PRODUCT/PROCESS CHANGE NOTICE (PCN)

PCN #: **TB1303-02** DATE: **April 1, 2013**
 Product Affected: Selective Non-Dry Pack Products
 shipped in Tape & Reel
 (Refer to Attachment 2)

ATTACHMENT 1 - PCN #: TB1303-02

Figure1: Illustration on Existing Packing and New Packing for Non-Dry Pack Products

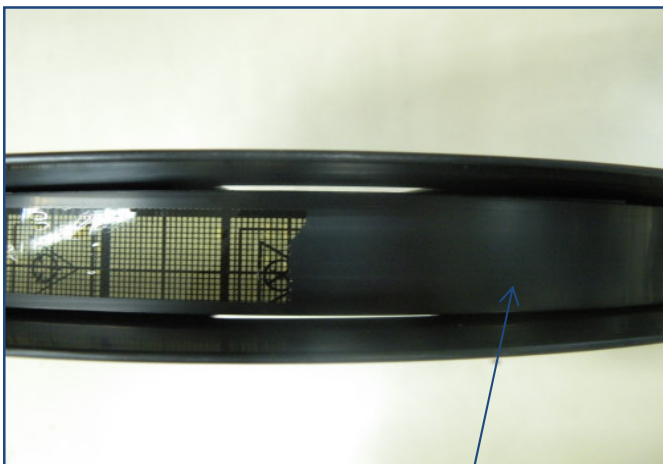
This notification is to advise our customers that IDT will be changing the packing method for selective Non-Dry Pack products (Moisture Sensitive Level 1) shipped in Tape & Reel. The new packing will be without the black protective band which is inserted in the outer carrier tape before the reel is packed into an ESD bag. All other packing materials remain unchanged.

A black protective band is inserted at the outer carrier tape before the reel is packed into an ESD bag.

New Packing -
Without Protective Band
